CARTERSVILLE HISTORIC PRESERVATION COMMISSION MEETING

CERTIFICATE OF PRESERVATION

- 2. COP23-03. 145 W Main St. Applicant: Scott Nicholls, rep.
- 3. COP23-04. 18 Wall St. Applicant: Adam Harper, new owner
- 4. COP23-05. 7 South Ave. Applicant: Jeff Spratt, owner

City of Cartersville Historic Preservation Commission COP Application Staff Report

SITE PLAN SCALE: 1" = 10'

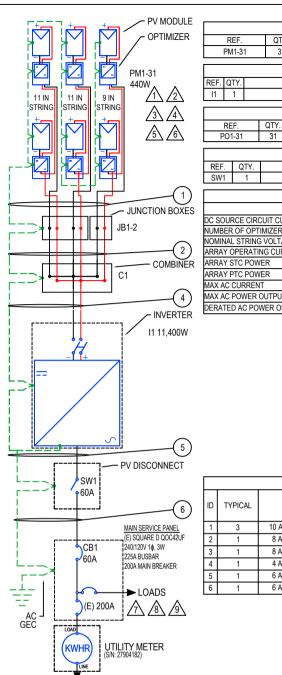
Thanks for the follow up. I'm headed out of town for the remainder of the week with limited email access. I may have some more questions to discuss with you next week when I'm back. The one question I currently have is will the panels be installed flat against the roof, flat- but raised up above the roof line, or tilted on angle. The (2) issues that need to be addressed from the historic district perspective is 1) will the panels be visible from Main or Noble Streets, and 2) will they create a reflective issue with adjacent, multi- story buildings?

They are a ballast mount that will be tilted 10 degrees. The ballast trays will sit directly on the roof. There will be no reflective issue as solar panels these days do not reflect so it will not disturb any of the surrounding buildings. The panel layout should not be visible from the street. Attached is the ballast mount for the racking.

FIRE SAFETY PLAN

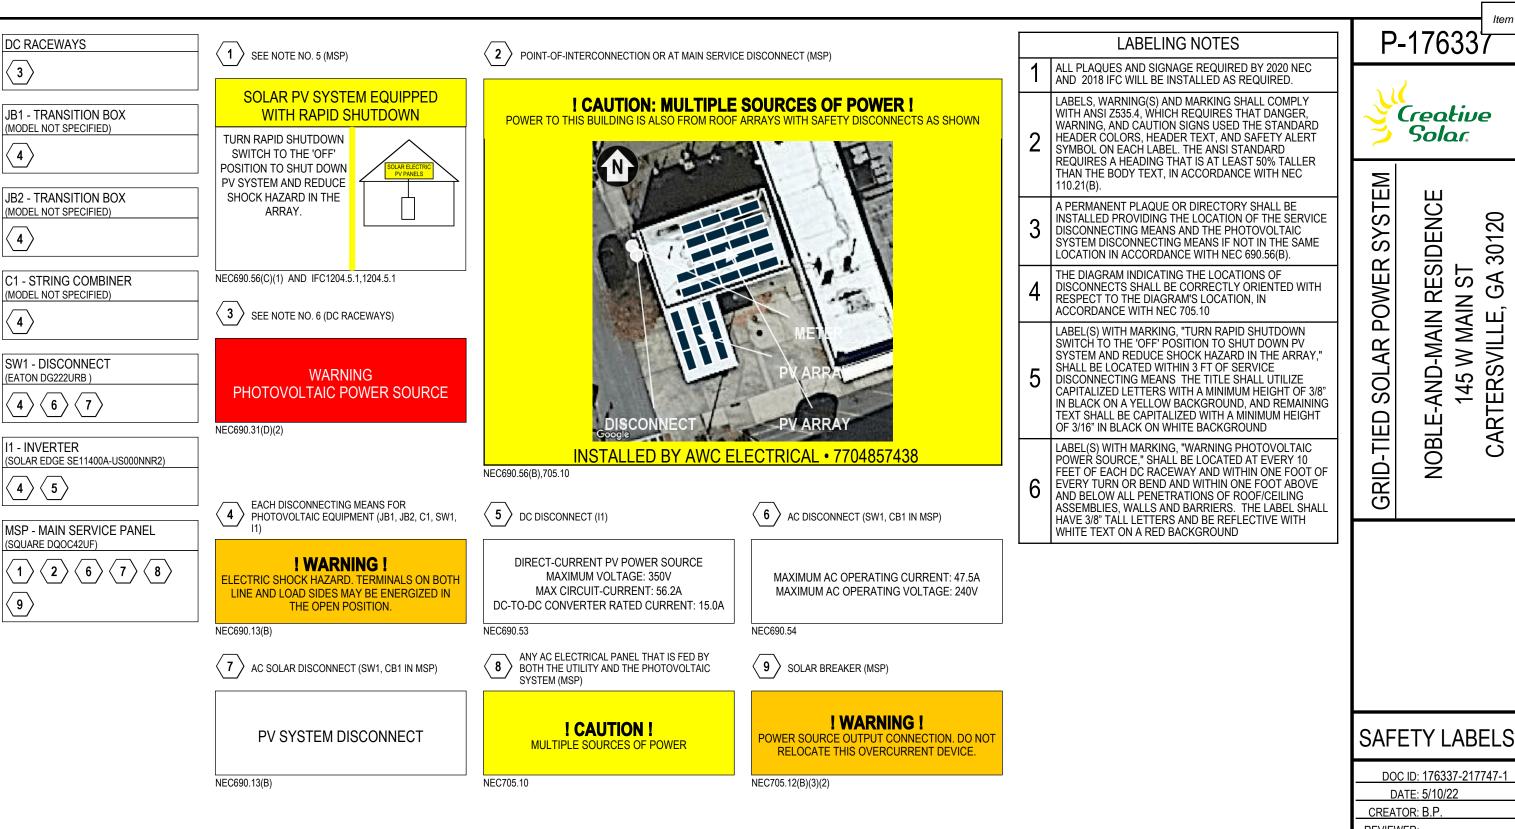
The proposed project is unique for the district. This is the first solar panel addition to a DBD building reviewed by the HPC. No other solar panels are known to exist downtown or visible in aerials.

The project proposes to install (31) HiMo panels, 82(L) x 41(W) x 1.4 (D), installed using the EcoFoot2+ low profile installation system on the roof of the building and canopy. The panels will be installed with a 10 degree tilt. Roof plans and details of the solar panels are provided.

The panels should be hidden from view from Noble St and from the site eastward on E. Main St. The panels will be visible from E. Main St west of the site due to the grade change and from 2nd and 3rd floor windows in the area. Other mechanical equipment like HVAC and exhaust systems are visible from ROWs.
